PERMIT #
PRBD202001527

PROJECT LOCATION	54 WESTLAKE CRES
LEGAL DESCRIPTION	PLAN 51M1137 LOT 147
WORK DESCRIPTION	DETACHED HOUSE BAROSSA 3 (S38-3) ELEV. A
OWNER NAME	BRADFORD EAST DEVELOPMENTS 111 CREDITSTONE RD CONCORD , ON L4K 1N3
APPLICANT NAME	ANDY MINATEL (BAYVIEW WELLINGTON HOMES)) 111 CREDITSTONE ROAD, CONCORD, ON L4K 1N3

ENGINEERING REVIEW

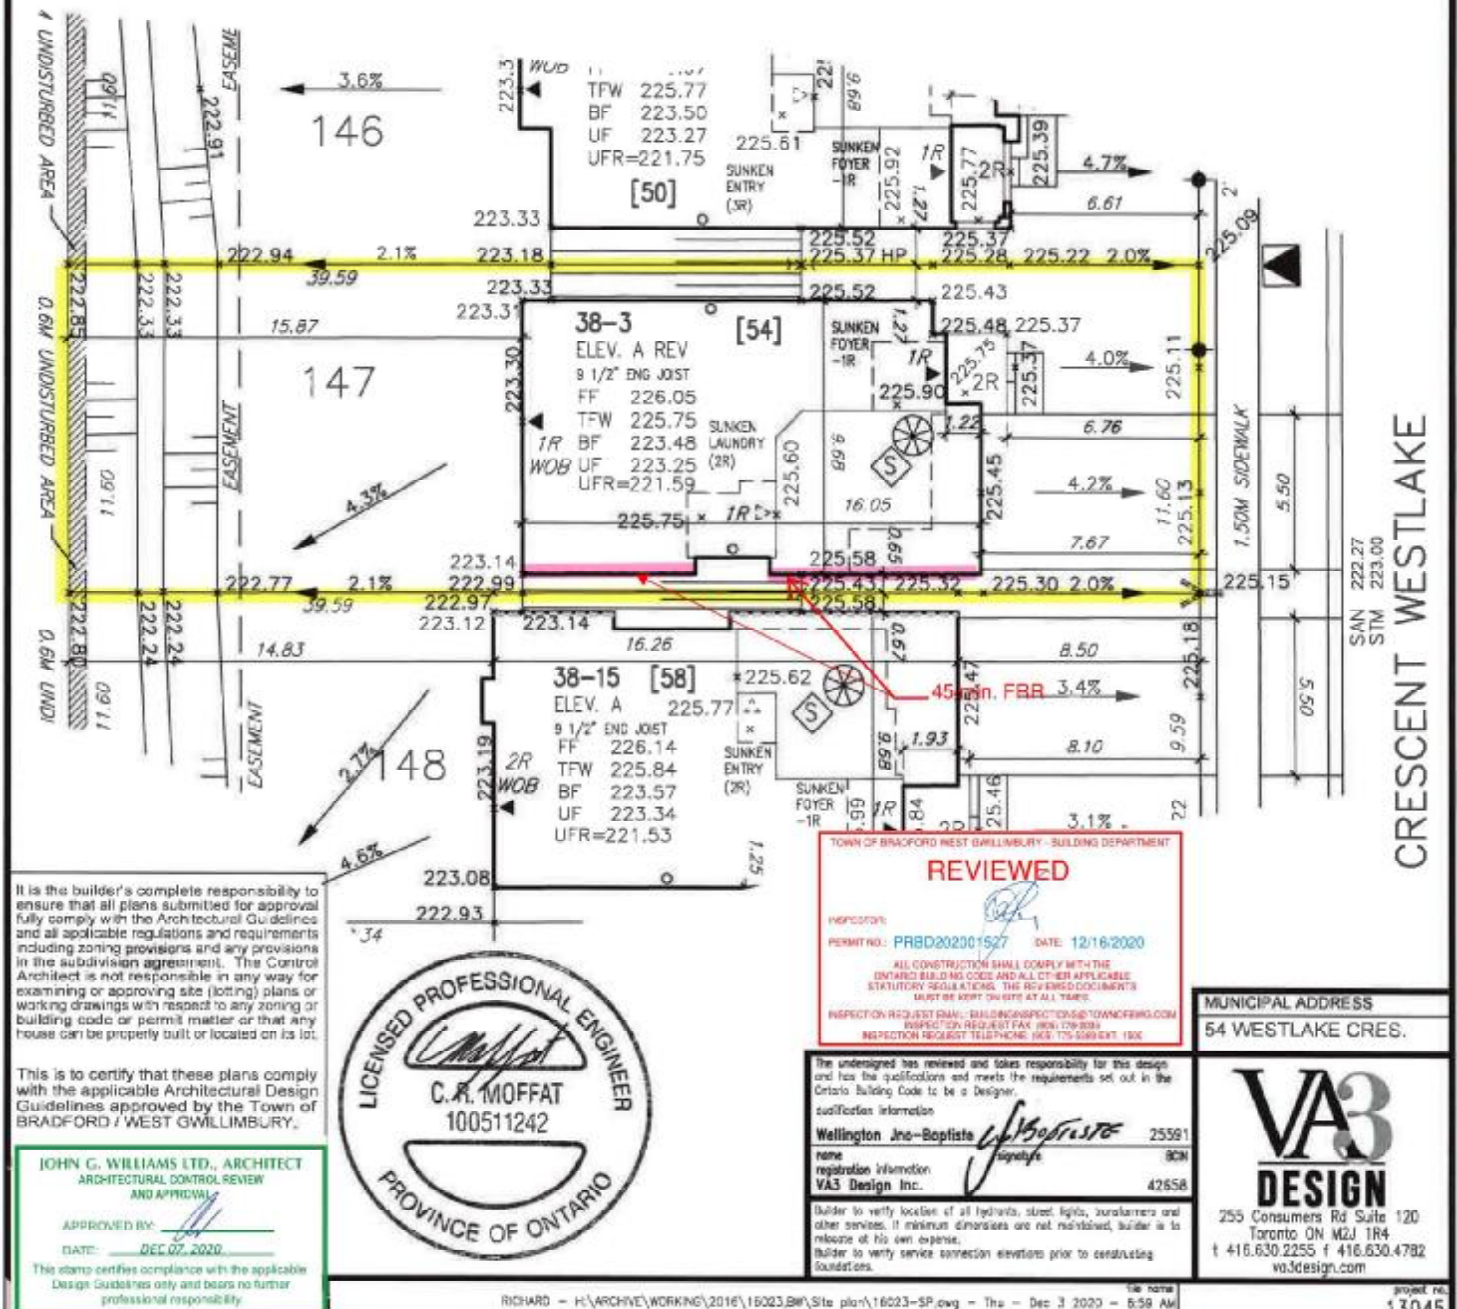
URBAN ECOSYSTEMS LTD. HAS REVIEWED THE PROPOSED GRADES AS SHOWN ON THIS PLAN AND HAS FOUND THEM TO BE IN GENERAL CONFORMANCE WITH THE APPROVED PLANS

- ☒ **ACCEPTED**
☐ ACCEPTED AS NOTED
☐ REQUIRES RE-SUBMISSION

THIS PLAN HAS BEEN REVIEWED WITH RESPECT TO GENERAL CONFORMANCE WITH THE OVERALL LOT GRADING PLAN AND OUR APPROVAL OF THIS PLAN FOR NO OTHER REASON. WE ACCEPT NO RESPONSIBILITY FOR THE ACCURACY OF THE ELEVATIONS AND DIMENSIONS PROVIDED BY OTHERS.
